# Memorandum

To: Wally Dubyk, CET (City of Ottawa, TES) Date: March 20, 2024  
 Copy: Harrison Da Costa (ML Devco - Client) Project: 476577-01000  
 From: Juan Lavin, P.Eng. / Jake Berube, P.Eng.  
 Subject: **398-406 Roosevelt Avenue TIA**  
**Addendum #1: Revised Site Plan (2024-01-24)**

Figure 2: Revised Site Plan - January 2024

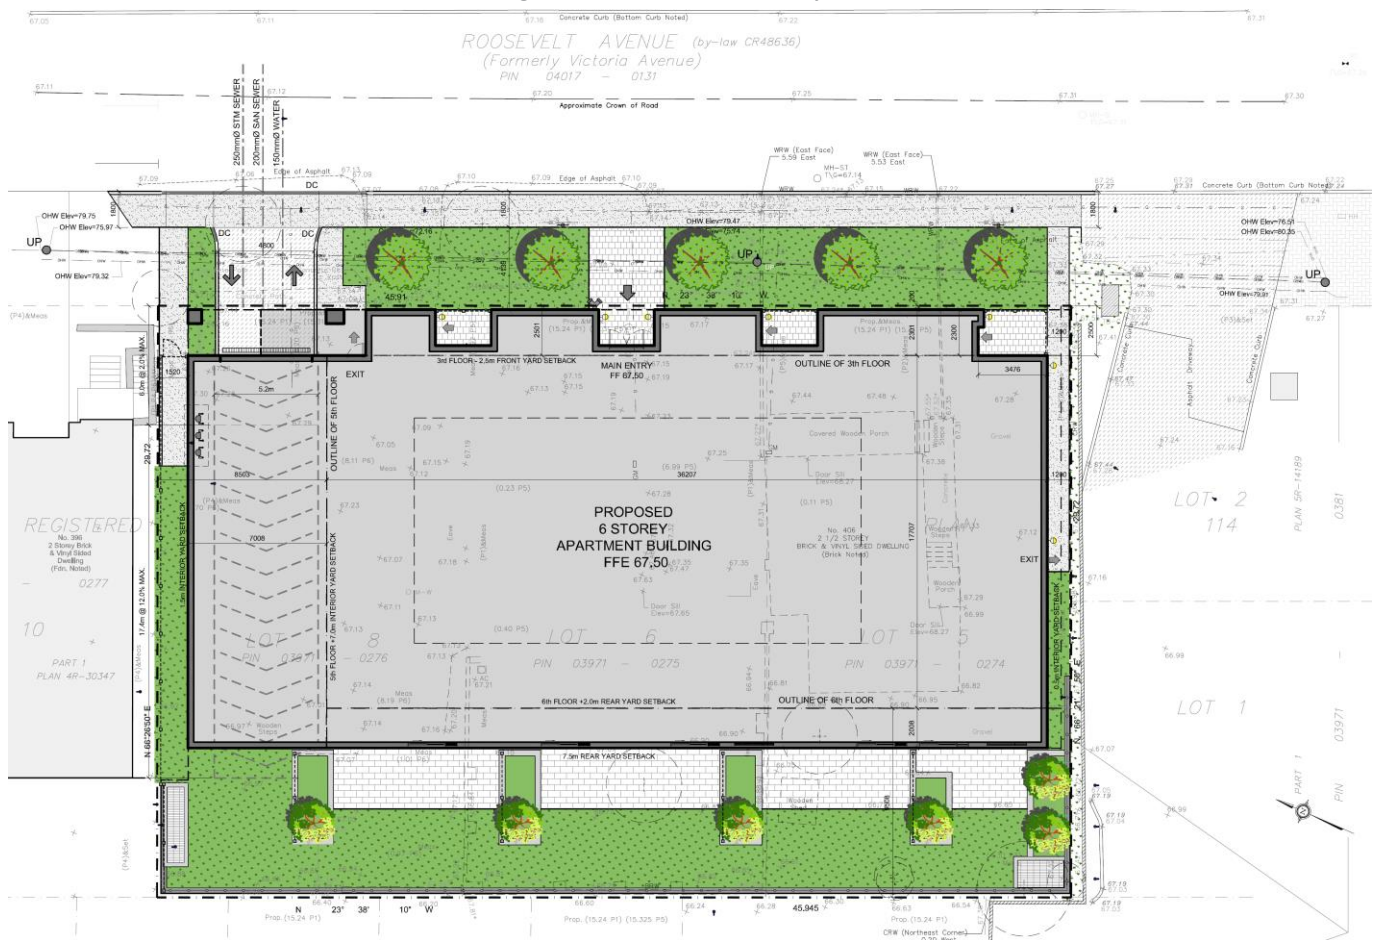
In comparison to the June 2022 site plan, the proposed site plan (January 24, 2024) includes an increase in residential apartment units, from 29 units to 62 units and a reduction in parking supply from 49 to 20 spaces. The increase in units has been accomplished by decreasing the unit floor area. The proposed Site Plan also proposes a parking ratio lower than the suggested Parking By-Law.

Overall, the site’s traffic circulation, location, quantity and dimensions for ramps and drive aisles have all remained consistent to the approved June 2022 Site Plan. Garbage pick-up is assumed at ground level on the street edge. There are no concerns or deviations noted from previously approved Site Plan, thus no further circulation analysis is required. **Table 1** below summarizes the new revised Site Plan statistics from January 2024 to the former approved Site Plan from June 2022.

The revised Site Plan proposes a reduction in parking spaces from 47 to 15 spaces (0.33 spaces/unit after applicable reductions, refer to **Table 2** footnotes) for residents and an increase in visitor parking spaces from 2 to 5 spaces (rate of 0.1 spaces/unit after applicable reductions) to meet the minimum visitor parking space requirements. **Table 2** summarizes the vehicle parking minimums required under the Parking By-Law. According to the City of Ottawa Parking By-Law, Part 4 Sections 100-114, the proposed development is located in Area B in Schedule 1 and Area X in Schedule 1A, within 600m walk to Kichi Sibi Rapid Transit Station according to Schedule 2A.

**SHEET TITLE:** SITE PLAN

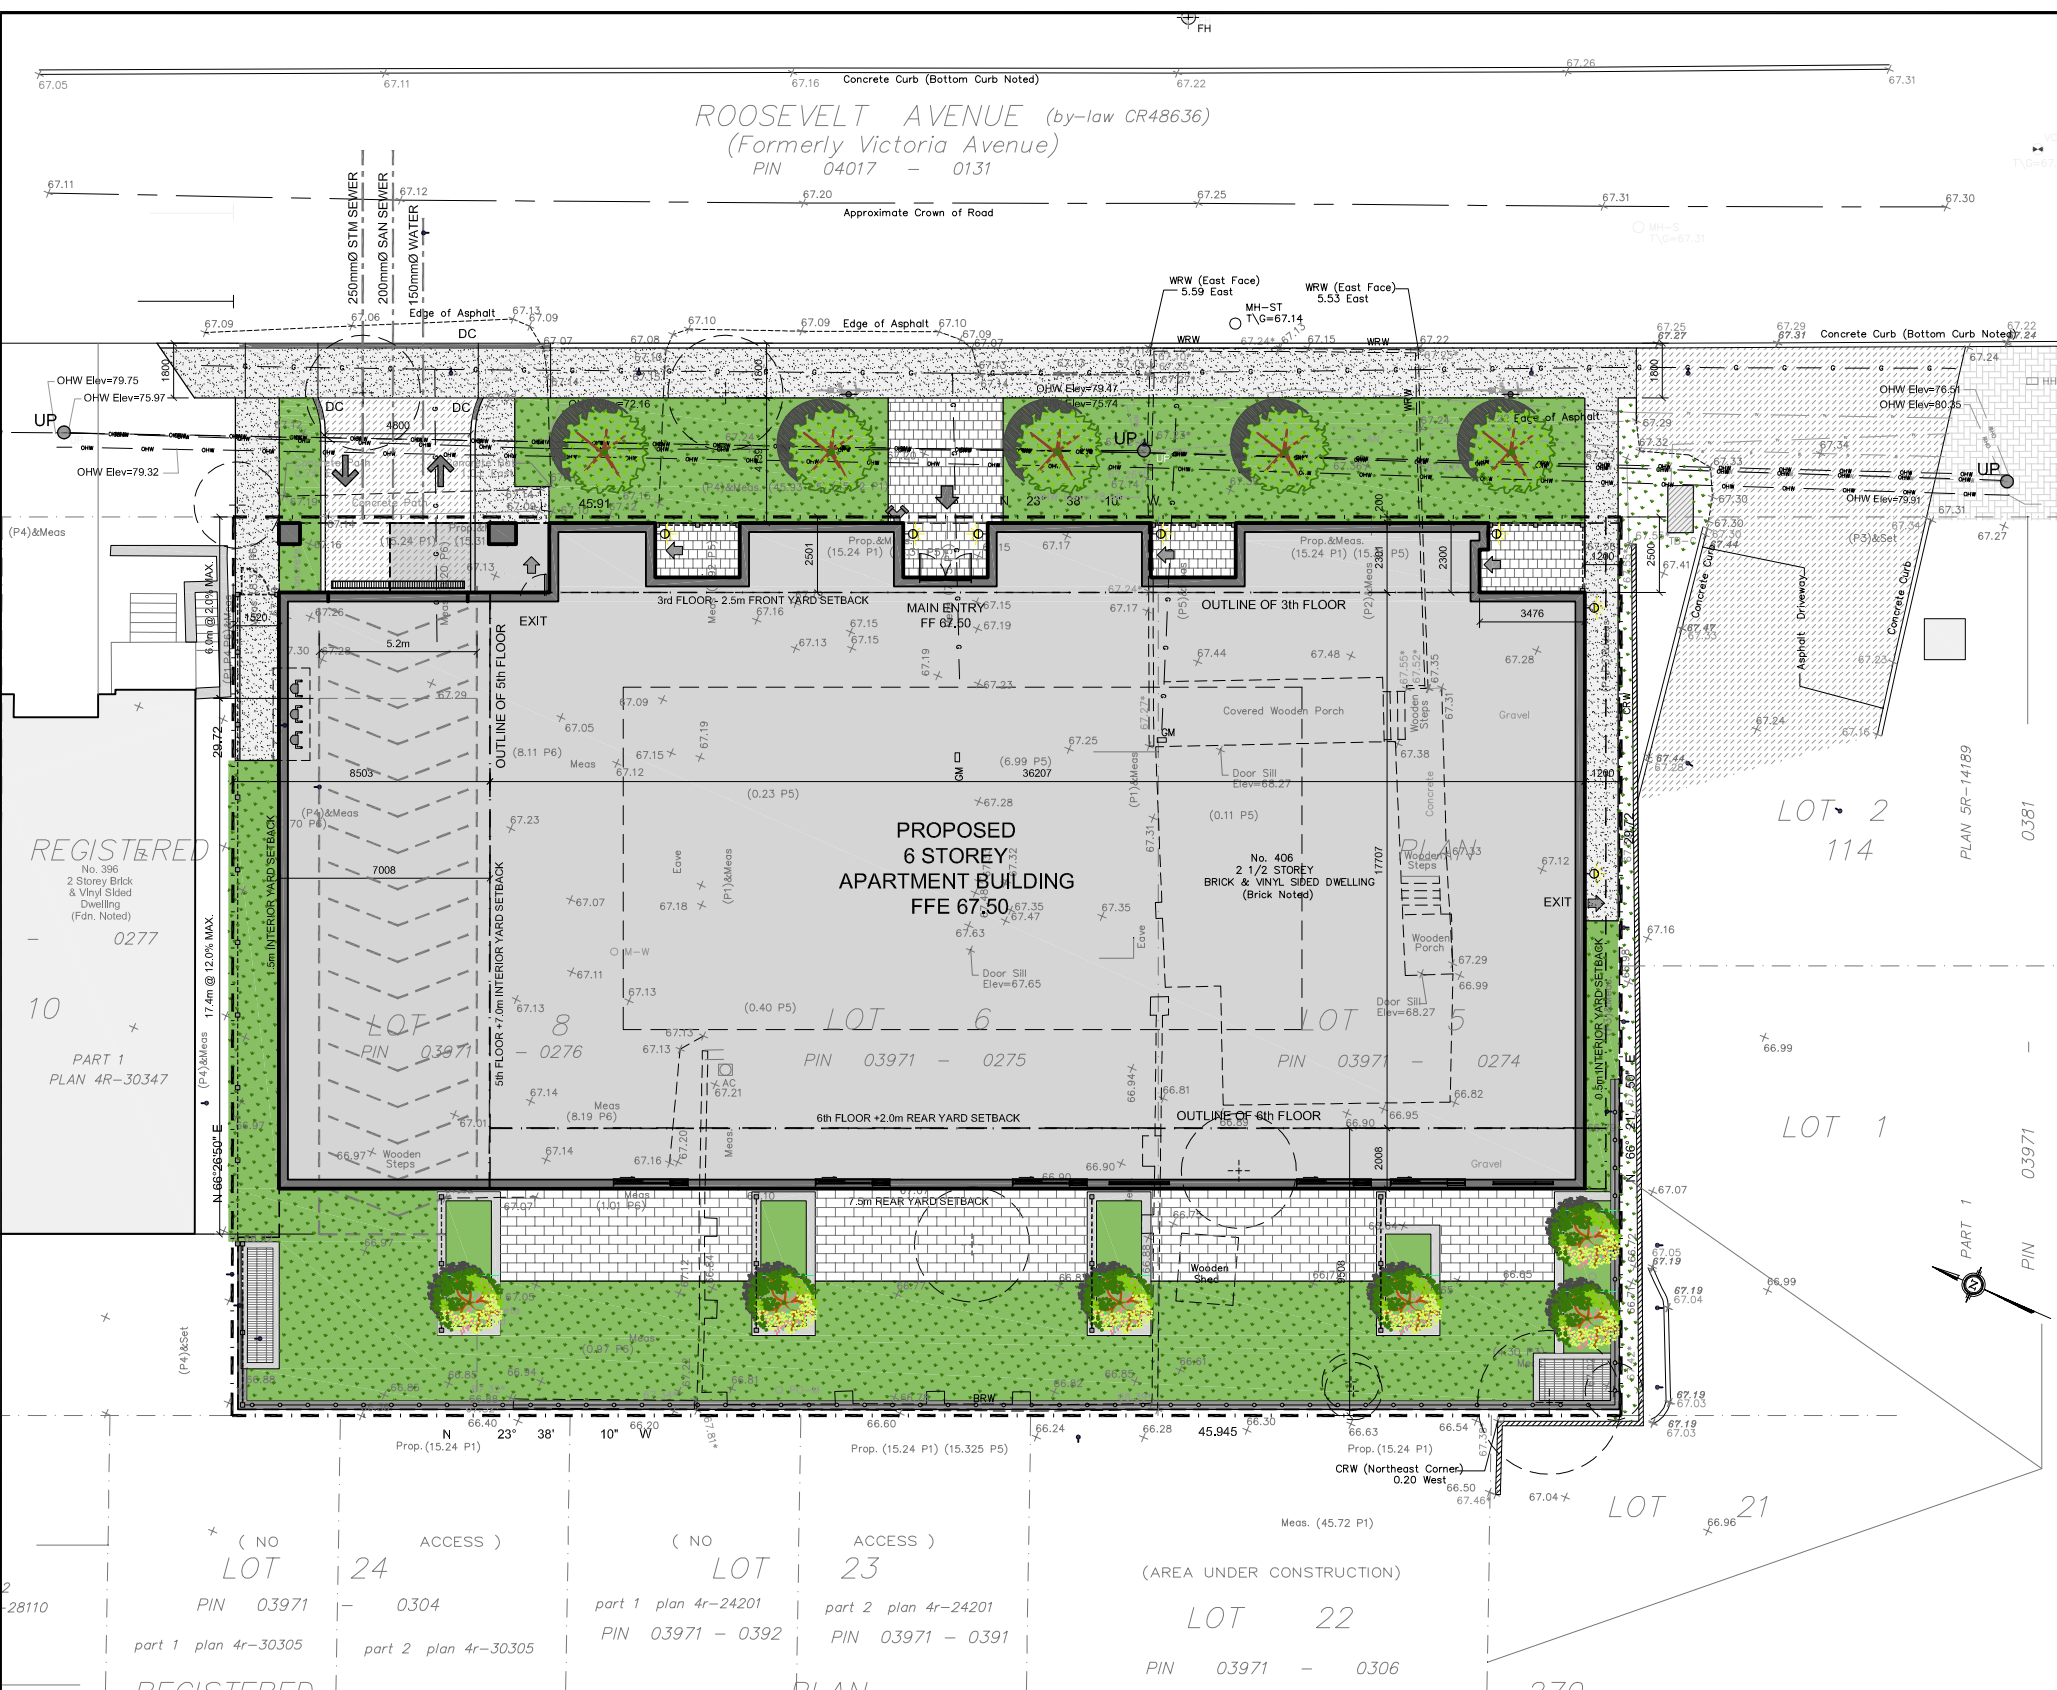
This Addendum has been prepared in support of an increase in residential unit count to 62 apartment dwelling units and a reduction in vehicle parking rate to 15 tenant stalls (0.33 stalls/unit after applicable reductions). The site circulation and access have remained unchanged. Policies from the Official Plan and Transportation Master Plan Updated demonstrate that the proposed site plan changes align with the guiding principles set by the City of Ottawa for new developments in this area. Given the ample cycling, walking and transit facilities near to the site and the general site context, there is sufficient support and justification to accommodate the proposed residential unit count and parking rate.
